PLANNING COMMISSION

Tuesday, June 11, 2024 at 6:00 PM
HYBRID: Council Chambers & Zoom (details below)

**CITY OF ST. HELENS PLANNING DEPARTMENT
STAFF REPORT
Variance V.5.24**

TO: Planning Commission acting as the Historic Landmarks Commission
FROM: Jennifer Dimsho, AICP, Associate Planner
RE: Architectural Character Review at 325 Strand Street
DATE: June 4, 2024

PROPOSED SITE PLAN WITHIN WATERFRONT DEVELOPMENT FRAMEWORK

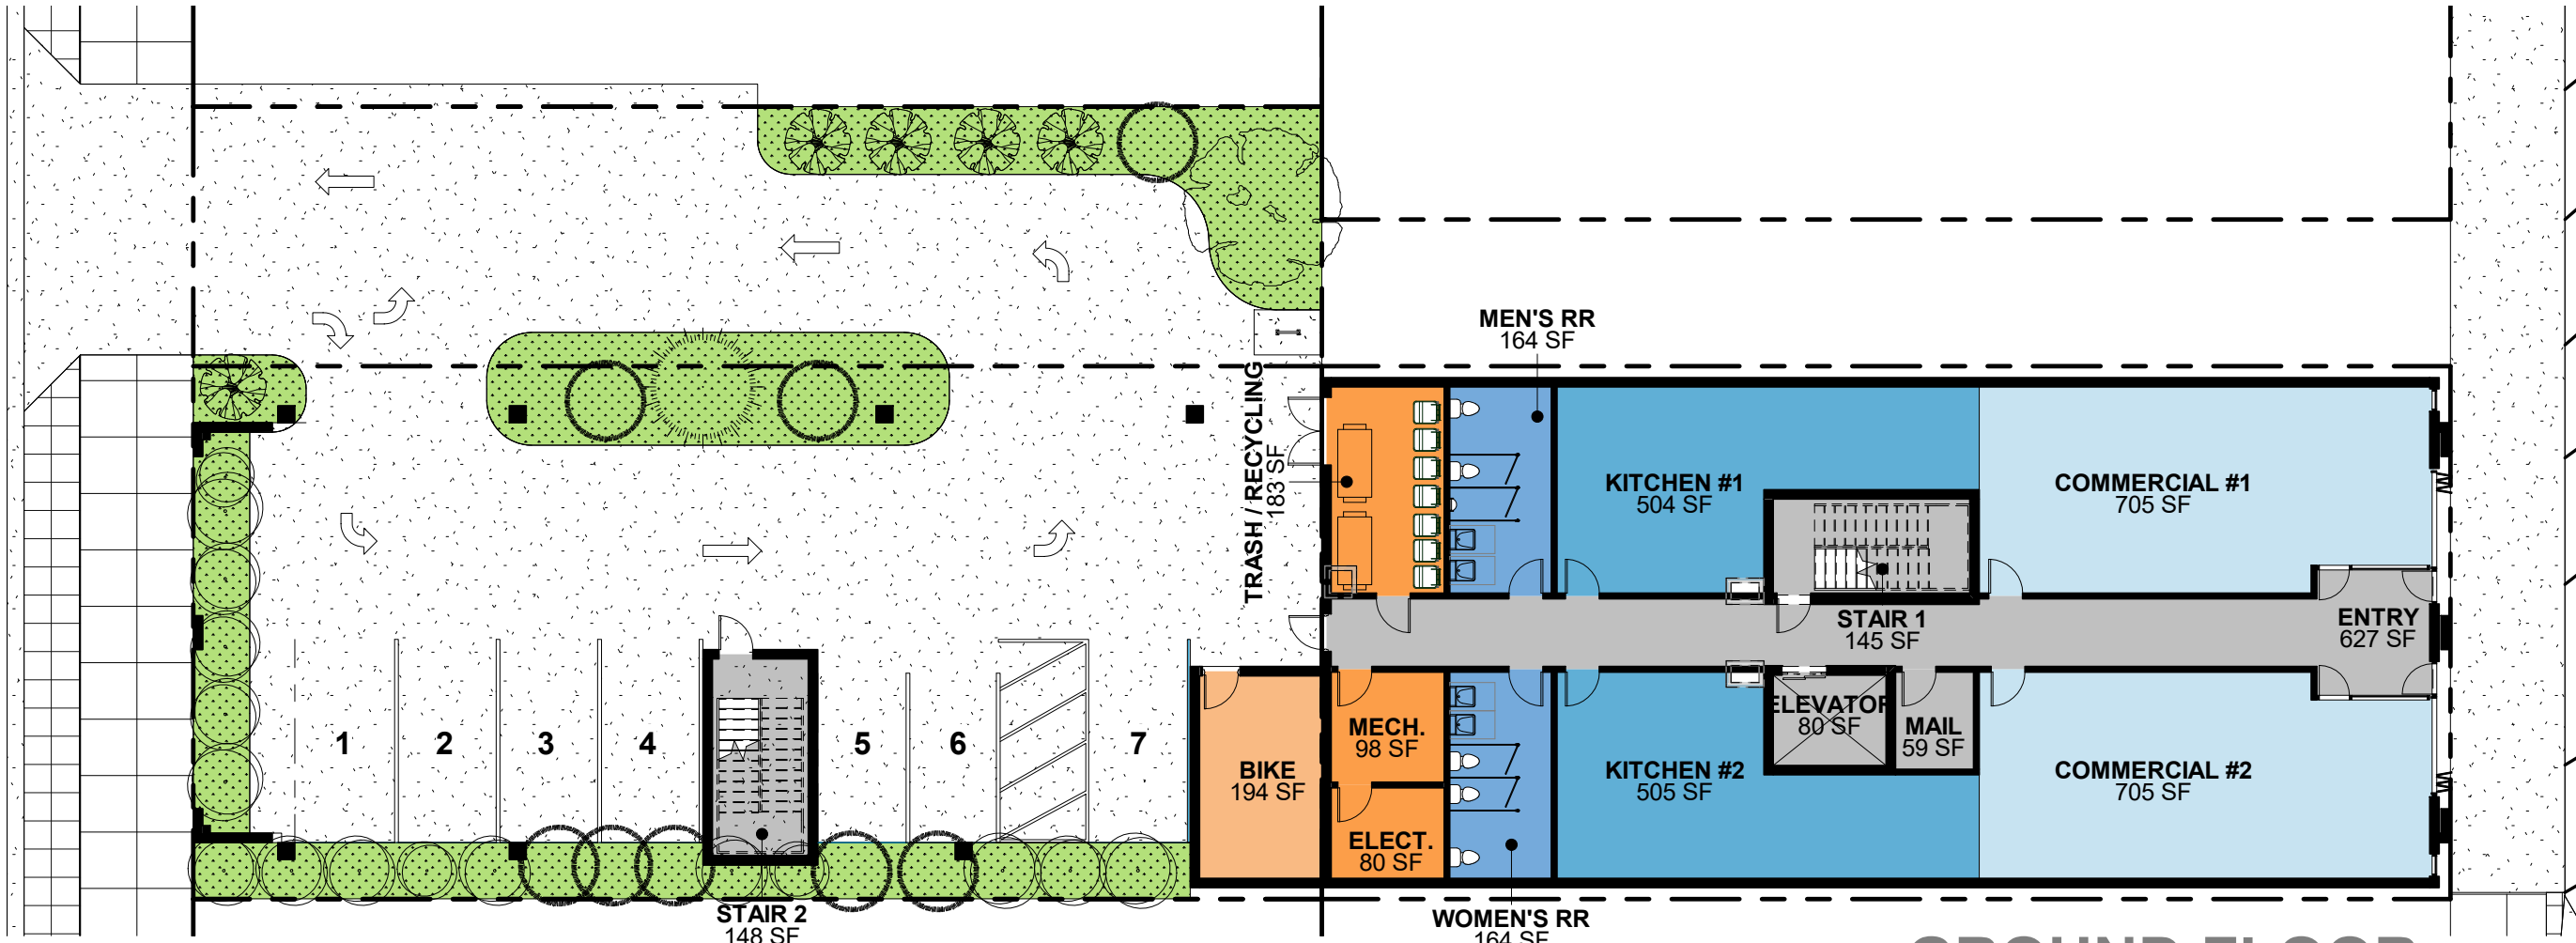
The subject property is not eligible for the parking exemption in (k) because the existing building footprint is proposed to be demolished as part of the development. However, the applicant discusses using the existing building as a key basis to grant the Variance. Note that the provision per (k) applies to existing footprint; the applicant’s plans show an expanded footprint. It also misrepresents the existing building footprint showing a portion along the west side that was demolished several years ago. Moreover, given the definition of “building” per Chapter 17.16 SHMC, which is a structure having a roof supported by columns or walls, if the roof is removed, it is no longer a building, and this exemption does not apply. Whether or not the roof can be saved, and multiple stories added and still meet this code is beyond the scope of this Variance; for the purpose of this Variance, there is no guarantee this is viable.

See Staff report Page 5 for a discussion about whether or not (4) (k) would apply if the roof were removed and multiple stories were added.

Current DAY Photo 5/20/24

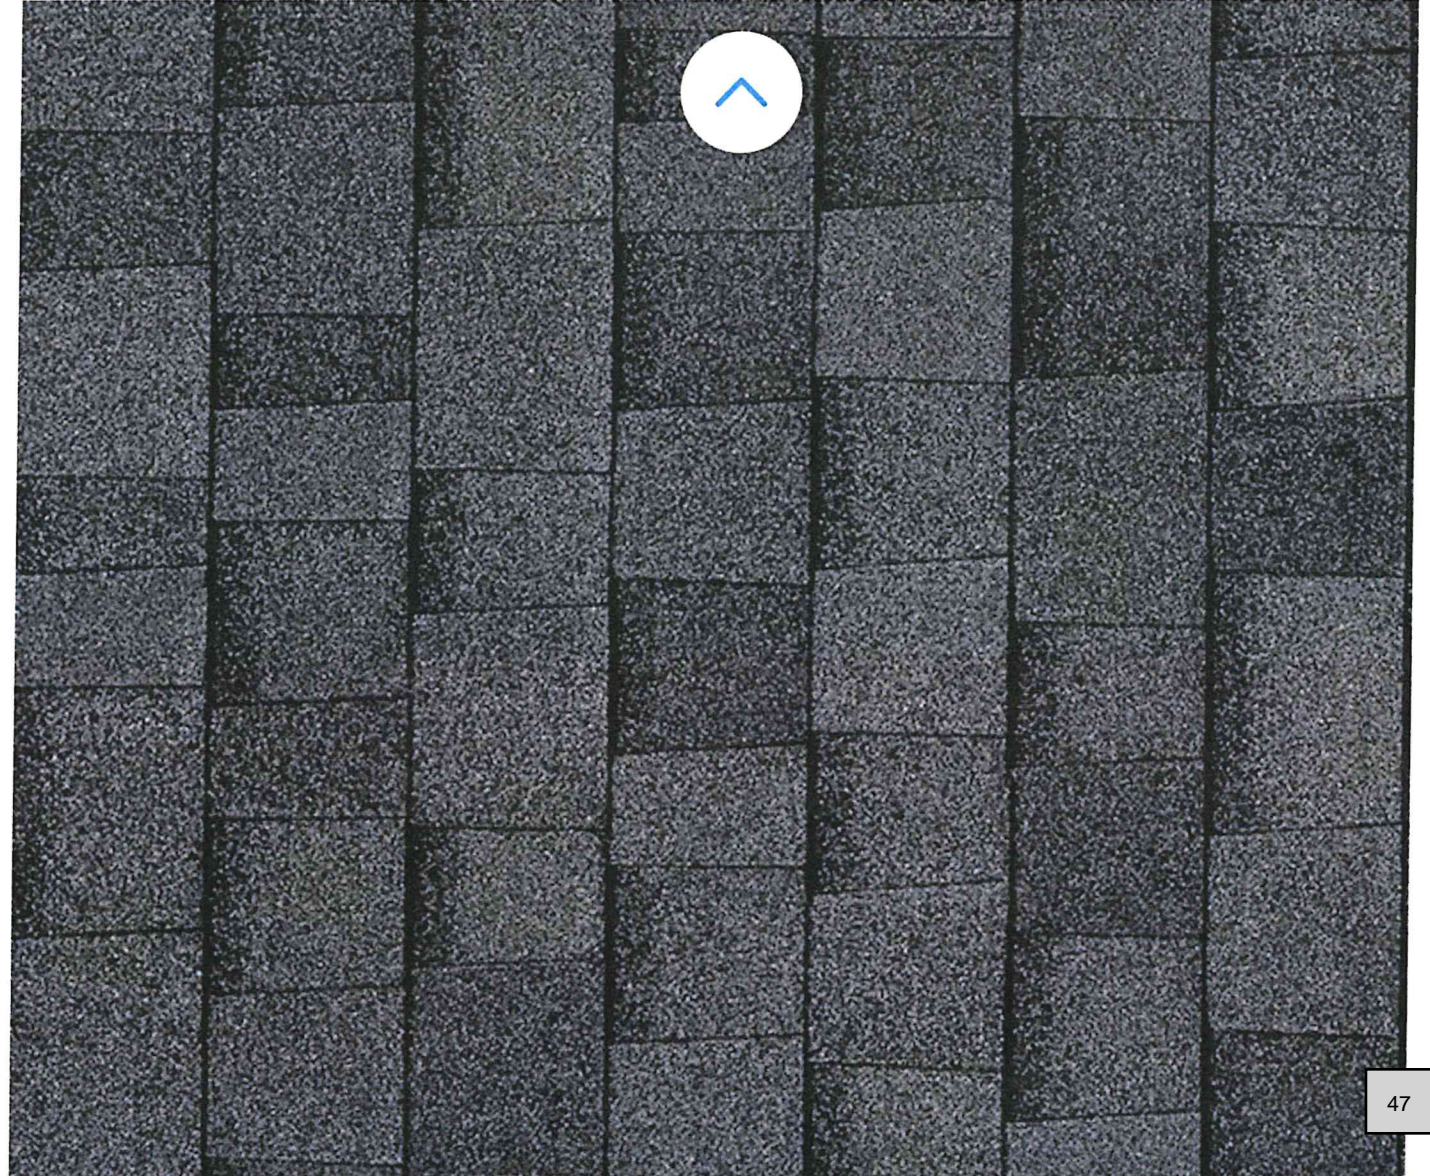
⑤ Safety ~~REQUIRED~~

③ Foundation HANDRAILS RUPALK NEEDED

Windows

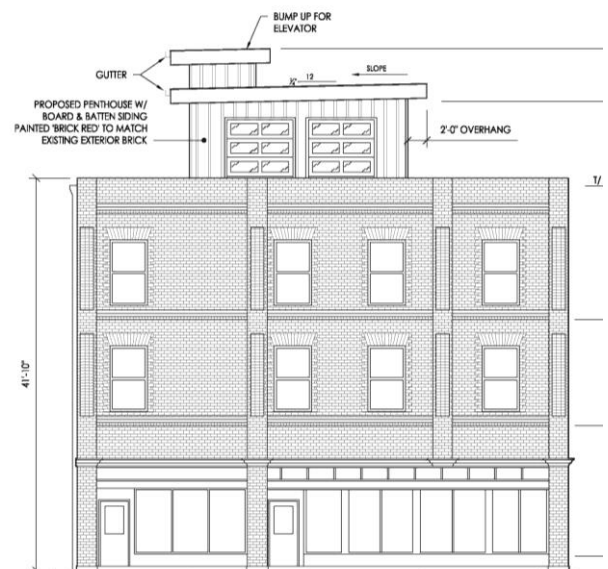
For new construction, the Guidelines state that storefront windows and upper-floor windows should incorporate appropriate traditional design that enhances the character-defining features of the district and neighboring historic resources. Specifically, they state that upper-story windows should have a vertical emphasis. For example, windows which are twice as tall vertically as they are wide are more traditional. They also state that upper story and storefront windows should be symmetrically placed and that the placement should consider neighboring buildings. The Guidelines encourage the use of transom windows, as well as window kickplates.

For the storefront side, the applicant incorporates storefront windows with transoms. **The large folding display windows are not necessarily traditional and do not incorporate a window kickplate, which was also discussed under Building Façade/Entry. Does the Commission want to recommend a change here?** Overall, the upper floor windows are more vertically oriented, although they are not necessarily symmetrical or continue/match the neighboring property, nor do they match traditional wall-to-window ratio. The applicant is likely trying to maximize the view of the river on the Strand Street side by including more windows to walls. Although a similar design is used on S. 1st Street. **Does the Commission want to recommend a more traditional wall-to-window ratio on the street frontages?** Both the south and north elevation have a more traditional window spacing and wall-to-window ratio.
